Our Reference 180974-04L-DD

Response to Council's Comments (Acoustics)
Proposed Place of Public Worship
1 Larapinta Place, Glenhaven

This letter provides Acoustic Consulting Engineers' response to The Hills Shire Council's comments in regards to *Item 4(b)* of the letter dated 3 May 2019 (Development Application 1867/2018/JP).

3.5 Outdoor Condenser Location

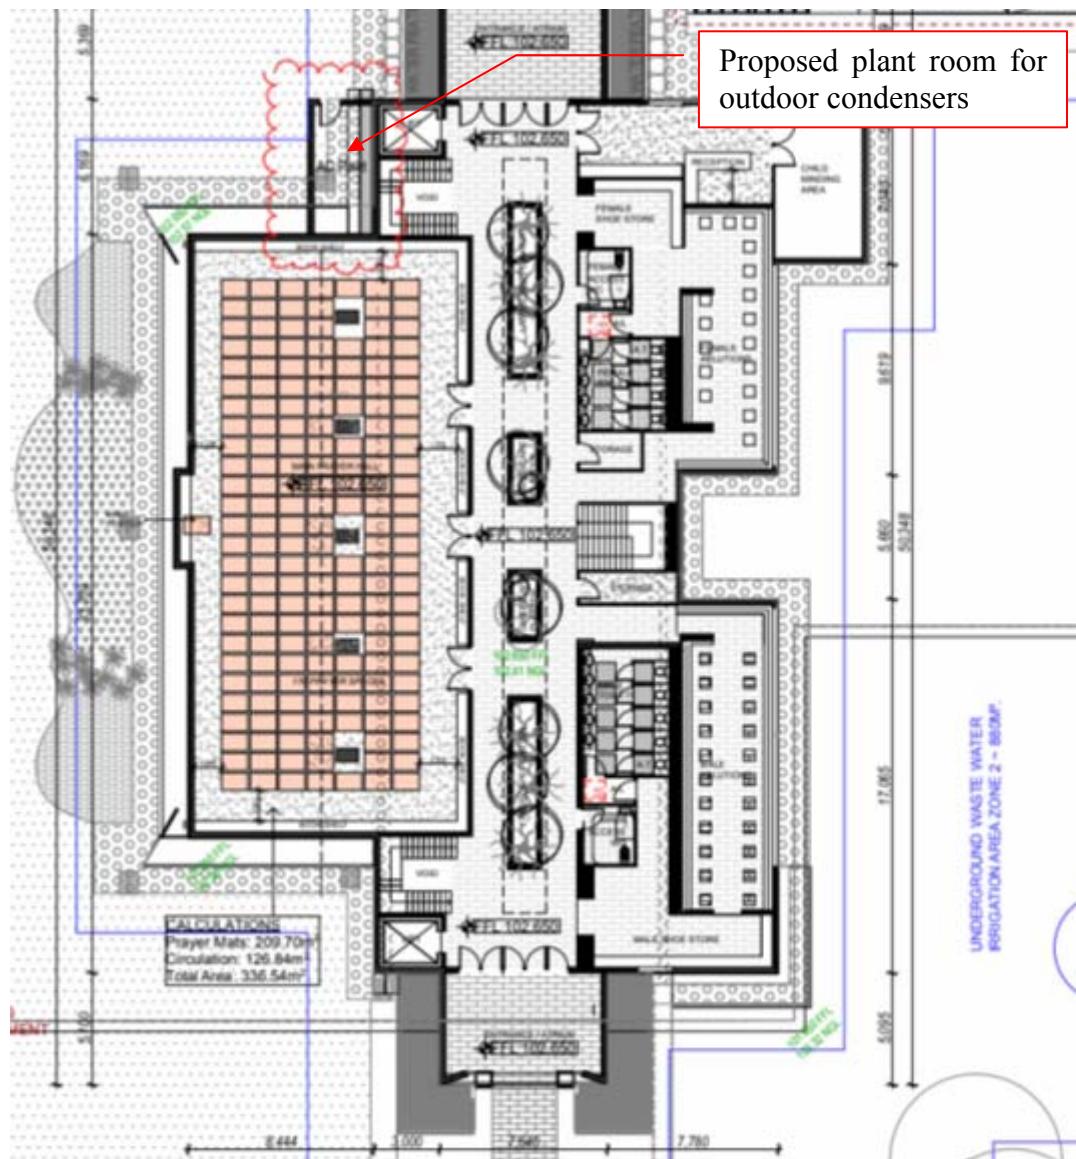
It is noted that the noise assessment nominates there will be up to eight split system air-conditioners and that these will be located on the western side of the building which would be facing Larapinta Place. This is not shown on the plans and will be essentially at the front of the building. It is required that the area for the proposed air-conditioners be planned and shown on a plan with any screening that may be proposed.

The figure below shows the proposed location of the plant room for the air-conditioning equipment outdoor condensers. Given the site location and distance separation, noise from the outdoor condensers will readily be controlled. Noise from the outdoor condensers will also be reviewed during the Construction Certificate (CC) Phase to address the relevant condition(s) of approval (if approval were granted).
